Ref: 17-000934.3015TM02.AM.rl

Subject: AURA Precinct 11 to 14 – Additional Engineering Information

This Technical Memorandum is to provide additional information following the EDQ Engineering Comments dated October 2020 and subsequent layout change.

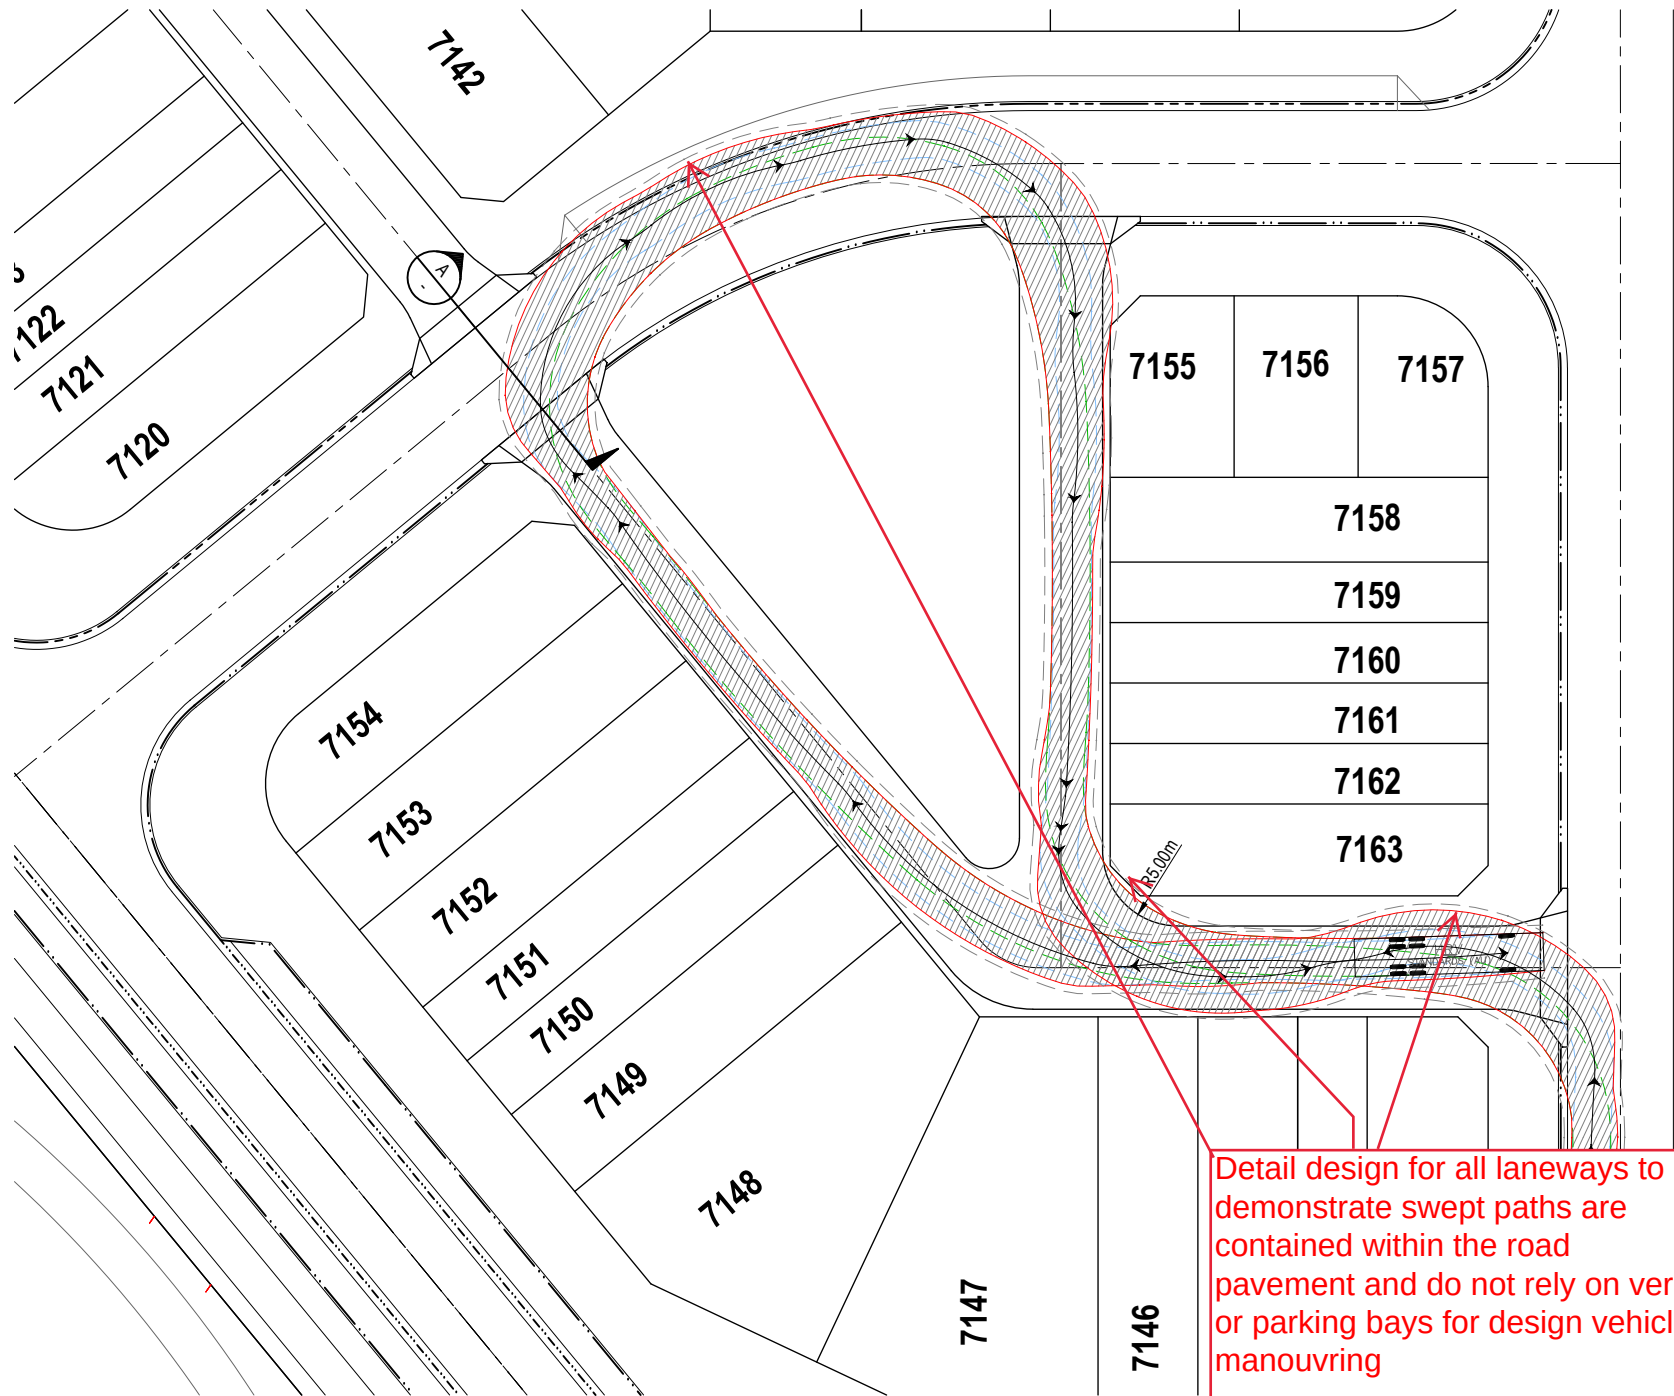
ROL Sheet 02 Item 3.

Reduced road reserves and carparking bays are proposed along the west boundary of Aura Brook in Stage 1141. Please provide cross sections to identify any level differences or retaining structures to demonstrate appropriate access to parked vehicles

Calibre Sketch plan **17-000934.3015-SK2001** provides concept details of the interface between Aura Brook and the adjacent carparking bays at Stage 1141. Details indicate there is a verge around the edge of the carparking bays before sloping down into Aura Brook channel. During the detailed design phase further details will be provided to ensure safe access is provided to the carparking bays.

DRAWING TITLE
**LANEWAY CONNECTION &
SWEPT PATH MOVEMENT
STAGE 1447 & 1449**

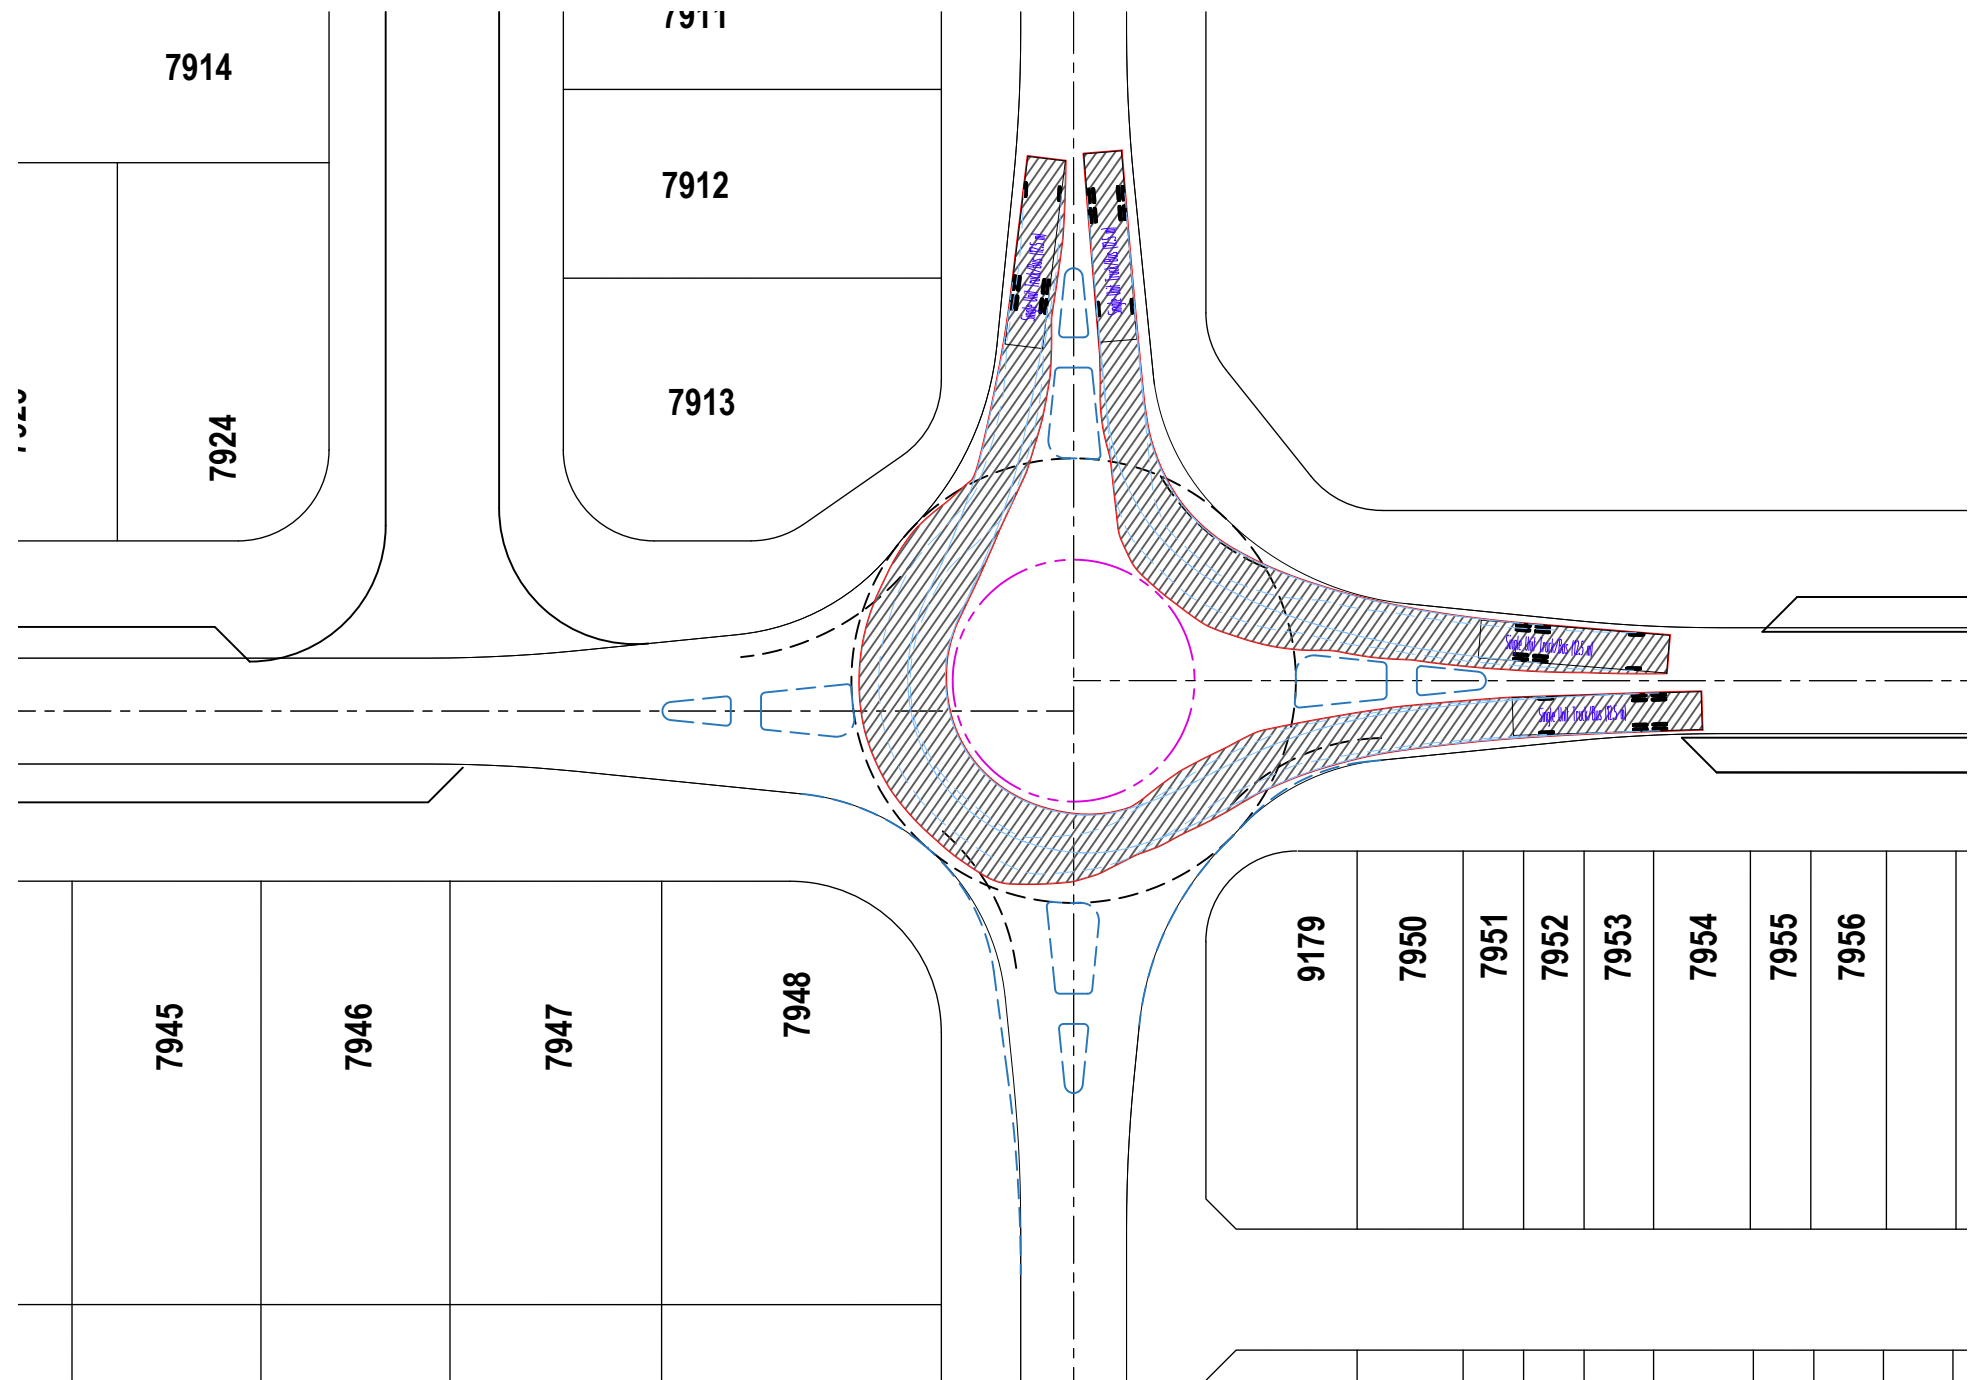
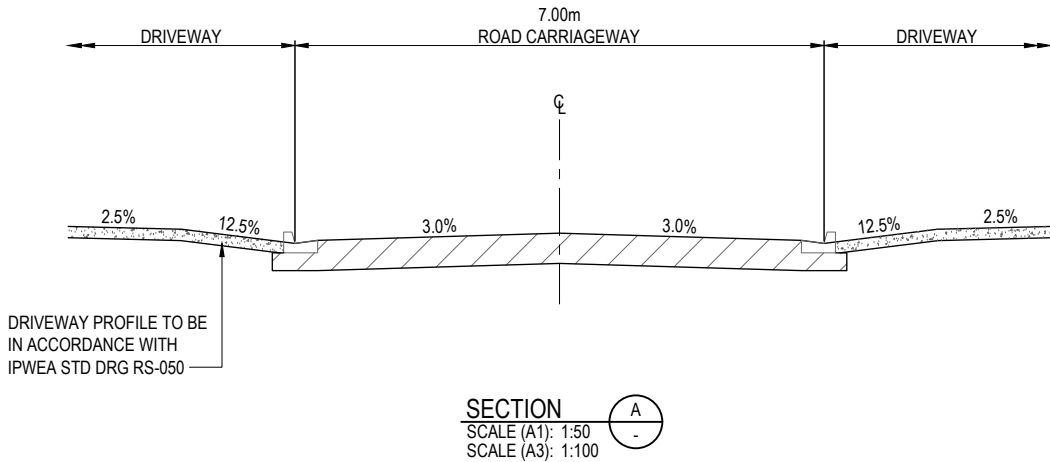
ROL Sheet 04 Item 1.

Stage 1447 features a number of 4 way intersections between laneways and streets that are considered undesirable. A traffic engineer needs to provide a statement of compliance with accepted current road design standards

ROL Sheet 4 Item 5

Provide swept paths for design vehicles to navigate network of pathways/ acute angles etc

Calibre Sketch plan **17-000934.3015-SK2002** demonstrates the driveway nature of the laneway entrances. The sketch plan demonstrates:

- Delineation of the higher order road with continuation of the kerb alignment and vehicle crossing
- Delineation of the higher order road with different surfacing texture and colour
- The cross section indicates the changes in elevation
- As such there is great clarity regarding the higher order roadway and priorities between turning movements.

Calibre Sketch plan **17-000934.3015-SK2002** which shows the swept paths movements for the most acute laneway scenario. As indicated later in this technical memo sketch plans have been prepared demonstrating manoeuvrability can be provided in the most constrained laneway route and therefore suitable throughout the Precinct 11 to 14 area. Refer to Calibre Sketch Plan **17-000934.3015-SK2009, SK2010, SK2011, SK2012 and SK2013**. See also responses above concerning vehicle swept path movements.

DRAWING TITLE	PROJECT No.	DRAWING No.	REVISION
ROUNDAABOUT	17-000934	3015-SK2005	-

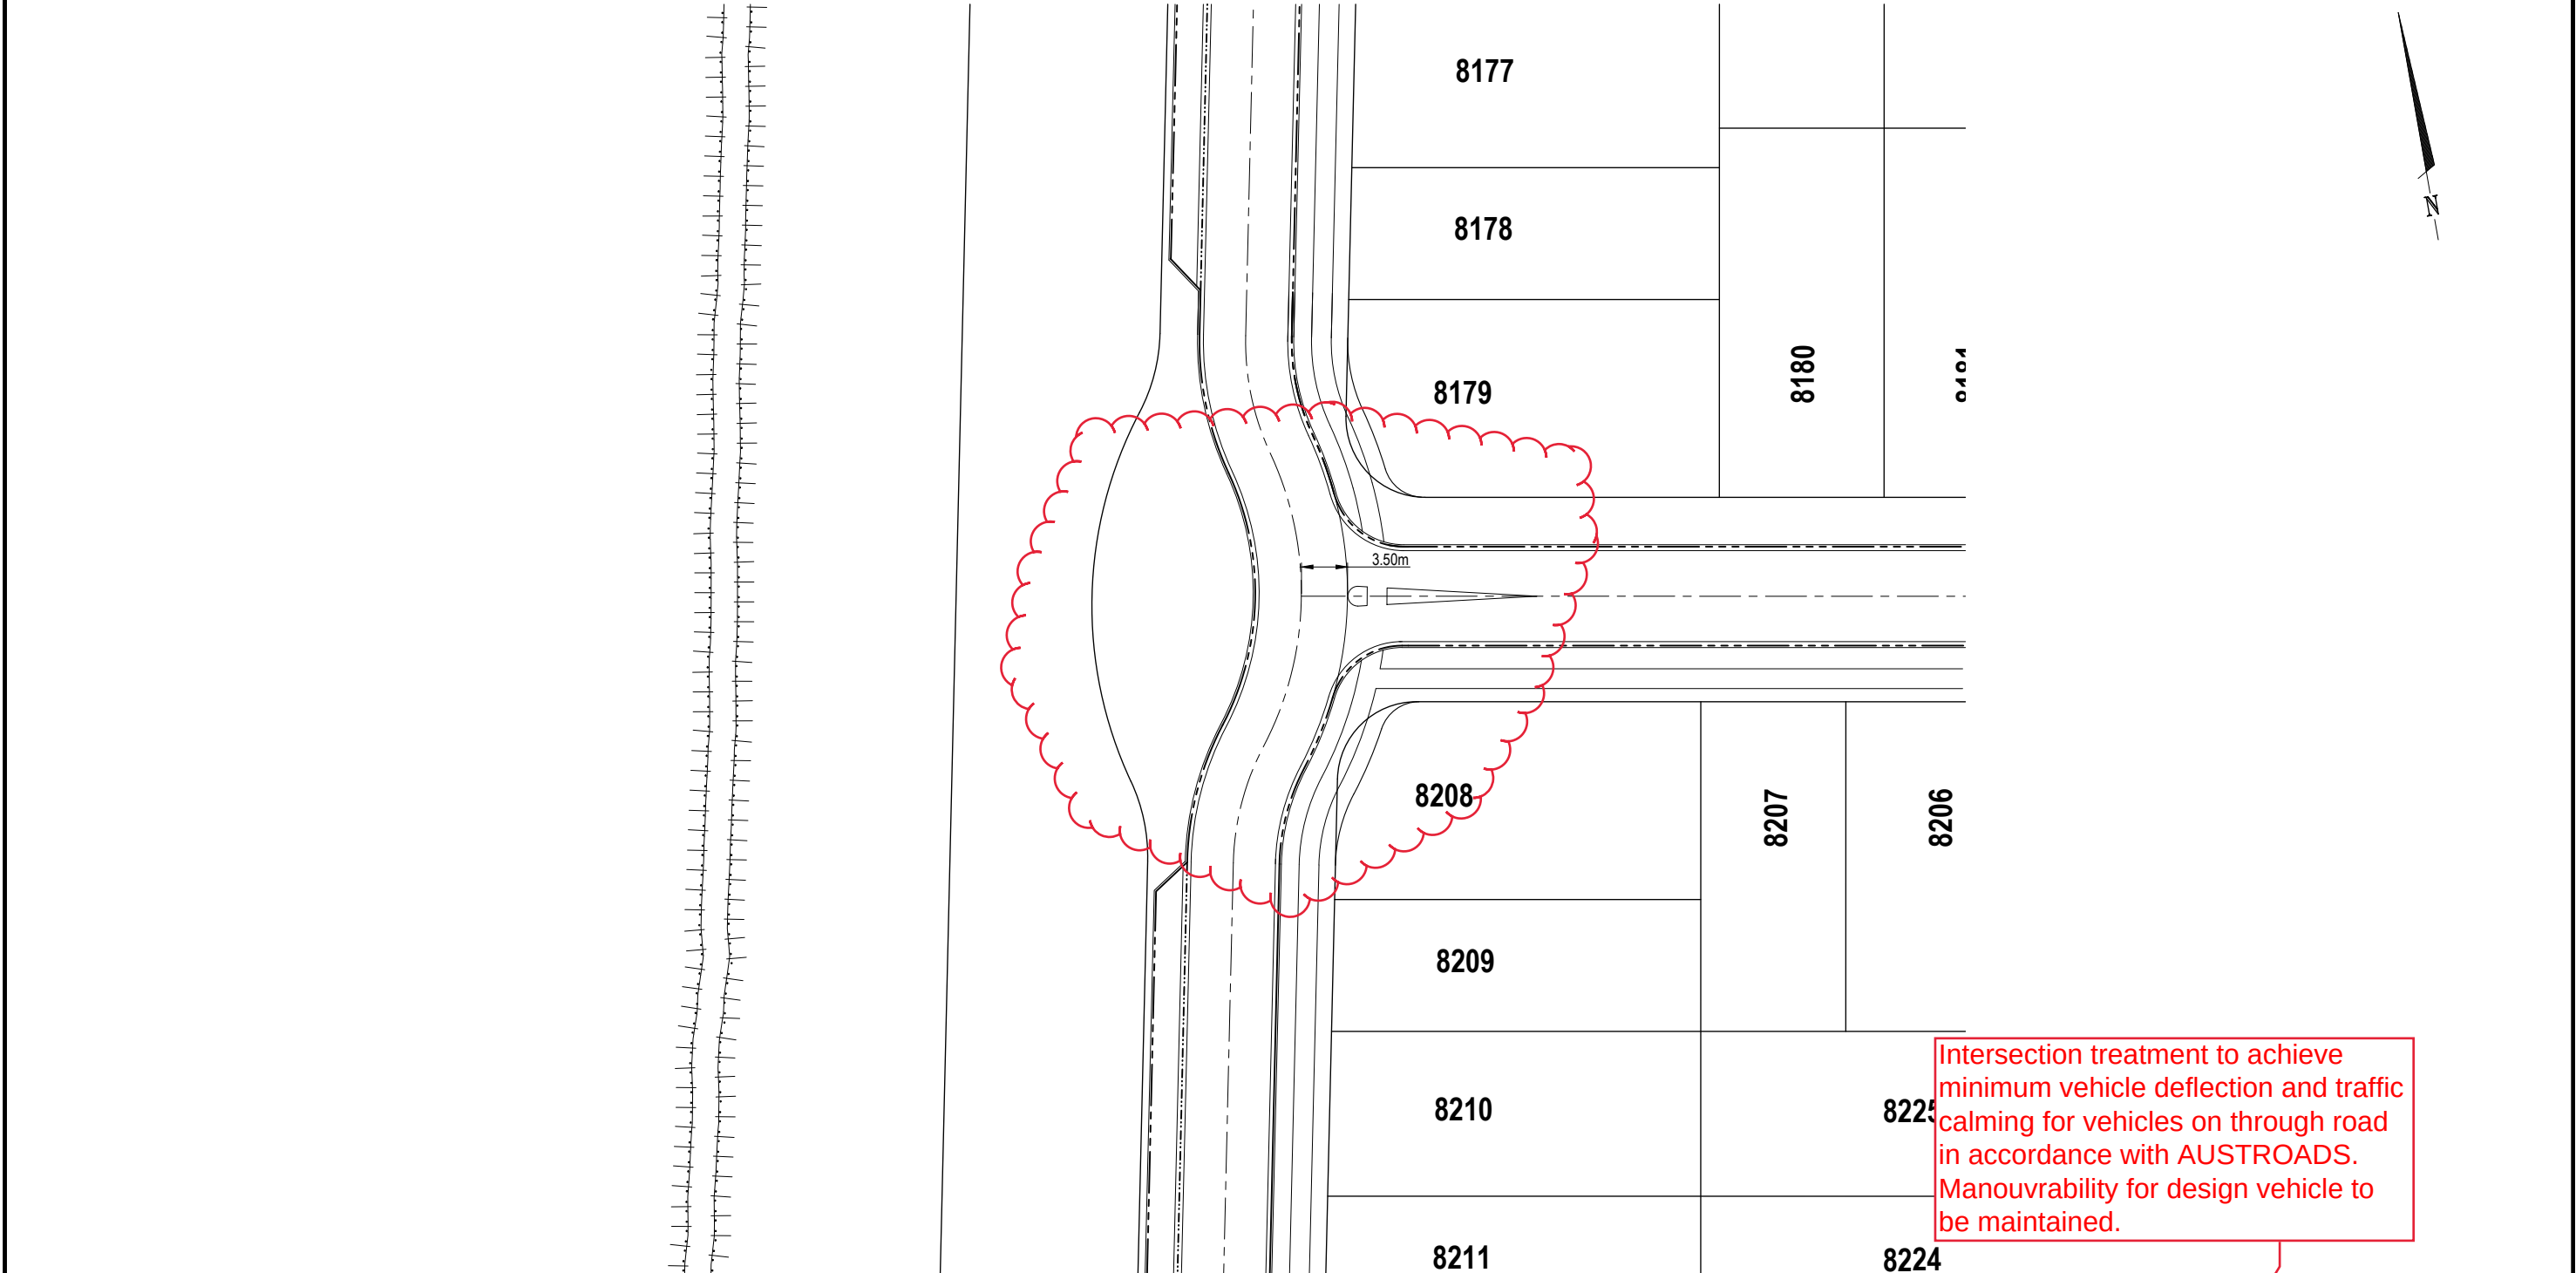
ROL Sheet 07 Item 2. Provide preliminary design of roundabout in Stage 1433 to demonstrate compliance with relevant standards in relation to vehicle deflection, provision of pedestrian and cyclist infrastructure, and accessibility for RCV and busses

Design review of the roundabout has been undertaken and the Urbis Overall Layout Plan road reserve widths has been changed to achieve suitable verge widths. Refer to Calibre Sketch Plan **17-000934.3015-SK2005** for the preliminary design roundabout layout.
